CITY PLAN COMMISSION**THURSDAY, NOVEMBER 7, 2024****FILE NUMBER:** S245-003**SENIOR PLANNER:** Hema Sharma**LOCATION:** Samuell Boulevard at Boone Avenue, southeast corner**DATE FILED:** October 9, 2024**ZONING:** MF-2(A)**CITY COUNCIL DISTRICT:** 2**SIZE OF REQUEST:** 2.064-acres**APPLICANT/OWNER:** General Housing Partners, LLC; 1742 Samuel LP**REQUEST:** An application to create one 2.064-acre lot from a tract of land in City Block 2664 on property located on Samuell Boulevard at Boone Avenue, southeast corner.**SUBDIVISION HISTORY:**

AERIAL MAP

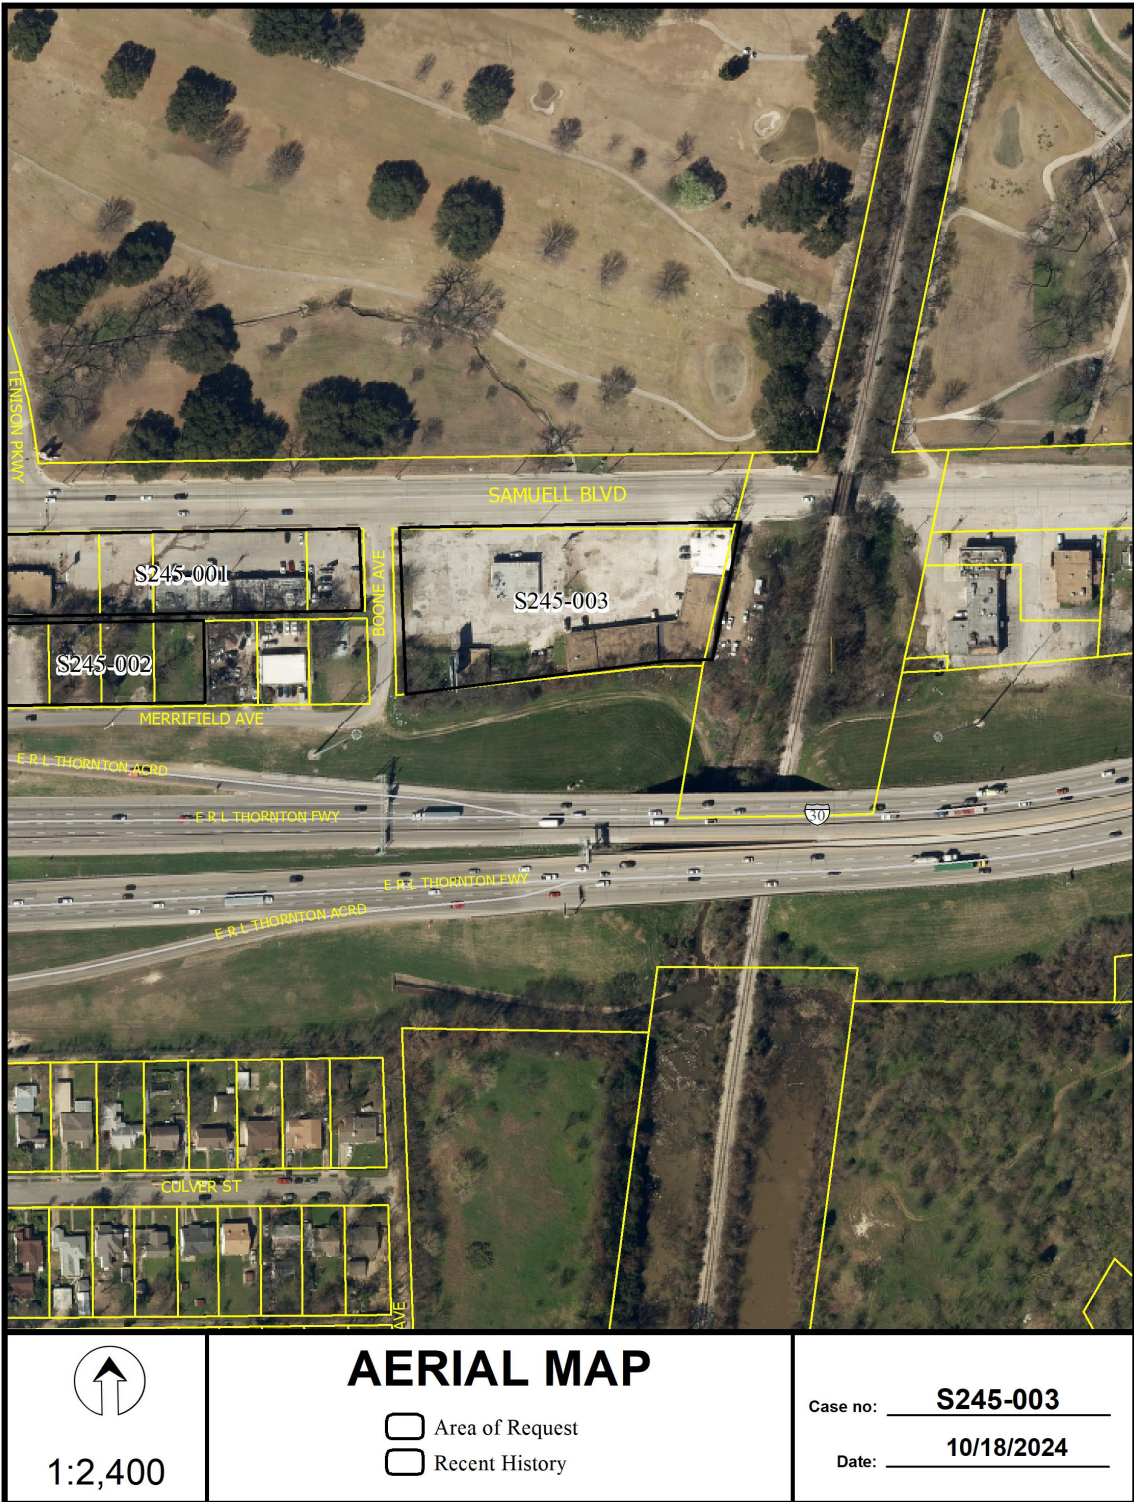
- S245-002 is a request west of the present request to replat a 0.7488-acre (32,618 square feet) tract of land containing all of Lots 8 through 11 in City Block F/2663 to create one lot and are zoned MF-2(A) Multifamily District. (*Refer to the existing area analysis map and aerial map*). The request is scheduled for City Plan Commission hearing on November 7, 2024.

- S245-001 is a request west of the present request to replat a 1.299-acre (56,598 square feet) tract of land containing all of Lots 1 through 7 in City Block F/2663 to create one lot and are zoned MF-2(A) Multifamily District. (*Refer to the existing area analysis map and aerial map*). The request is scheduled for City Plan Commission hearing on November 7, 2024.

- The properties to the west and south of the present request has lot areas ranging in size from 8,151 square feet to 9,431.5 square feet and are zoned MF-2(A) Multifamily District and RR Regional Retail District. (*Refer to the existing area analysis map and aerial map*)
